From: Campos, Alicia@Energy
Sent: Tuesday, January 08, 2013 12:41 PM
To: Campos, Alicia@Energy
Subject: FW: AES Redondo Data Adequacy Assessment final.pdf - Adobe Acrobat Standard
Attachments: AES Redondo Data Adequacy Assessment final II.pdf

DOCKETED
12-AFC-03

AES Redondo Application Data Adequacy Assessment

AES Redondo Data Adequacy Assessment

Figure 2: Oblique view of AES site shows how any 85 foot facility would dominate the surrounding uses.

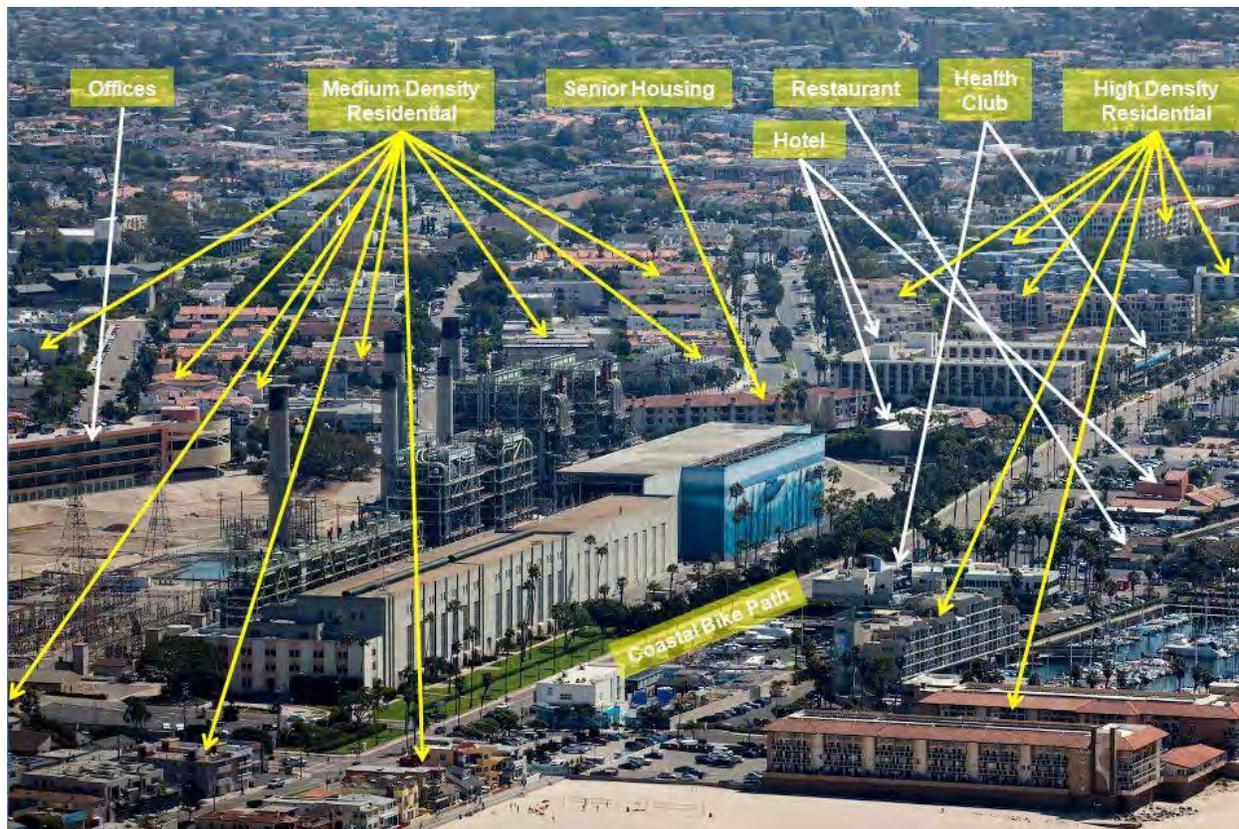
Figure 2 gives a better perspective of the site and its close proximity to incompatible uses. There is no denying that an 80 foot high power plant anywhere on this site will have a dominant and unavoidable negative impact on all the surrounding uses. While AES tells the public the plant will be hidden from most views, the site and proximity make this impossible.

Figure 3 demonstrates that AES' current plan moves the new plant closer to high density residential neighborhoods and offices, further exacerbating the impacts from conditions today. The new positioning eliminates any buffer between residential neighborhood and office uses. This was likely done by AES to allow the maximum land availability for conversion to undefined "mixed use" development as AES has advertised in its public marketing. Mitigation of power plant impacts should be the first priority over reuse of the unused AES property, especially since the power plant is incompatible with land uses on all sides of its property line. Clearly, centering the power plant on the property is most appropriate. While this may impact AES' desired construction schedule due to impacts on the current plant, it represents the best long term operational solution.
